Contract #: 04-0120F4Cty: SF/ALA Rte: 80 PM: 13.2/13.9File #: 69.25B**QUALITY ASSURANCE -- NON-CONFORMANCE REPORT****Location:** Changxing Island, Shanghai, China**Report No:** NCR-000908**Prime Contractor:** American Bridge/Fluor Enterprises, a JV**Date:** 23-Nov-2010**Submitting Contractor:** Zhenhua Port Machinery Company, Ltd (ZPMC), Changxing Island**NCR #:** ZPMC-0870**Type of problem:****Welding****Concrete****Other****Welding****Curing****Procedural****Bridge No:** 34-0006**Joint fit-up****Coating****Other****Component:** Lift 13AE, SEG3007Q-104**Procedural****Procedural****Description:****Reference Description:** New Welding Procedure Not Followed (Rager/McQuaid)**Description of Non-Conformance:**

**To:** AMERICAN BRIDGE/FLUOR, A JV  
375 BURMA ROAD  
OAKLAND CA 95607  
**Date:** 25-Nov-2010  
**Contract No:** 04-0120F4  
04-SF-80-13.2 / 13.9  
**Dear:** Mr. Charles Kanapicki  
**Job Name:** SAS Superstructure  
**Attention:** Mr. Thomas Nilsson Project/Fabrication Manager  
**Document No:** 05.03.06-000865  
**Subject:** NCR No. ZPMC-0870  
**Reference Description:** New Welding Procedure Not Followed (Rager/McQuaid)

Contract #: 04-0120F4Cty: SF/ALA Rte: 80 PM: 13.2/13.

-Weld number identified as SEG3007Q-104

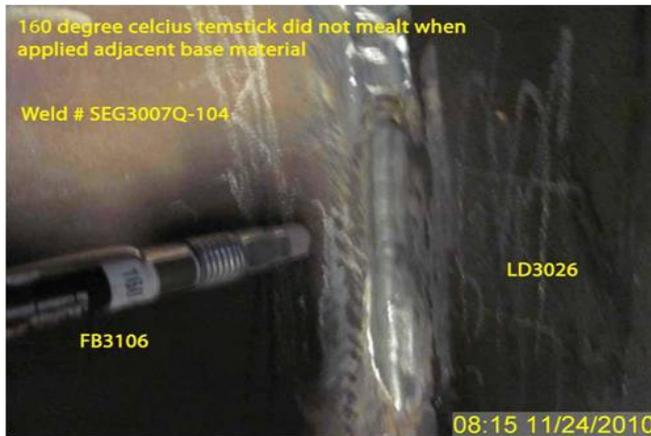
- ZPMC personnel performed weld repair for the weld between longitudinal diaphragm (LD3026) and floor beam web (FB3106) without adequate preheating of the adjacent base material.

- ZPMC did not perform NDT (Magnetic Particle testing) on the weld excavated area.

- ZPMC did not perform PWHT after complete weld repair before the temperature falls below the preheat temperature

-During the welding This QA Inspector observed a 160 degree Celsius Tempstick did not melt when applied to the adjacent base material.

-Did not appear any electric strip heaters or torch

2) Assembly:F. Preheat shall be applied in such manner to provide a minimum temperature in the area of the weld 165 degree Celsius

5) Post weld thermal treatment: A. After welding is completed but before the temperature falls below that of the preheat temperature, post heat shall be applied to maintain the temperature in the area of the weld at 165 C - 225°C

6) Non destructive testing :A All back gouged groove welds are to have their gouged areas ground to bright metal and inspected 100% by VT and MT examination before welding may begin from the second side

See attached NDT results to show the weld is acceptable. Based on this ZPMC requests closure of this NCR.

This proposed resolution is acceptable. The documentation received is sufficient and the Department concurs that Non-Conformance ZPMC-0870 is closed.

-Weld number identified as SEG3007Q-104

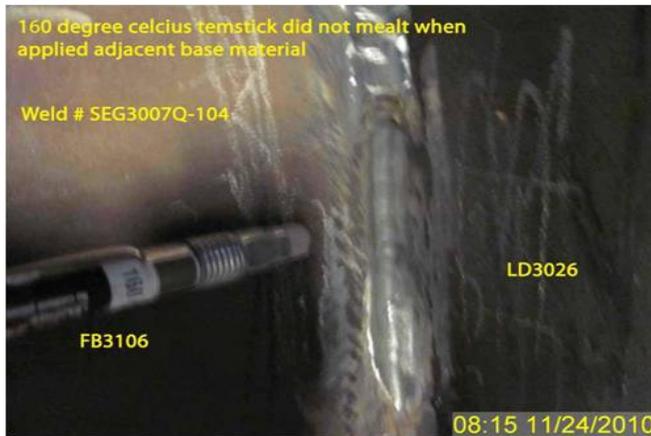
- ZPMC personnel performed weld repair for the weld between longitudinal diaphragm (LD3026) and floor beam web (FB3106) without adequate preheating of the adjacent base material.

- ZPMC did not perform NDT (Magnetic Particle testing) on the weld excavated area.

- ZPMC did not perform PWHT after complete weld repair before the temperature falls below the preheat temperature

-During the welding This QA Inspector observed a 160 degree Celsius Tempstick did not melt when applied to the adjacent base material.

-Did not appear any electric strip heaters or torch

2) Assembly:F. Preheat shall be applied in such manner to provide a minimum temperature in the area of the weld 165 degree Celsius

5) Post weld thermal treatment: A. After welding is completed but before the temperature falls below that of the preheat temperature, post heat shall be applied to maintain the temperature in the area of the weld at 165 C - 225°C

6) Non destructive testing :A All back gouged groove welds are to have their gouged areas ground to bright metal and inspected 100% by VT and MT examination before welding may begin from the second side

Contractor will provide the NDT report to prove the weld is acceptable.
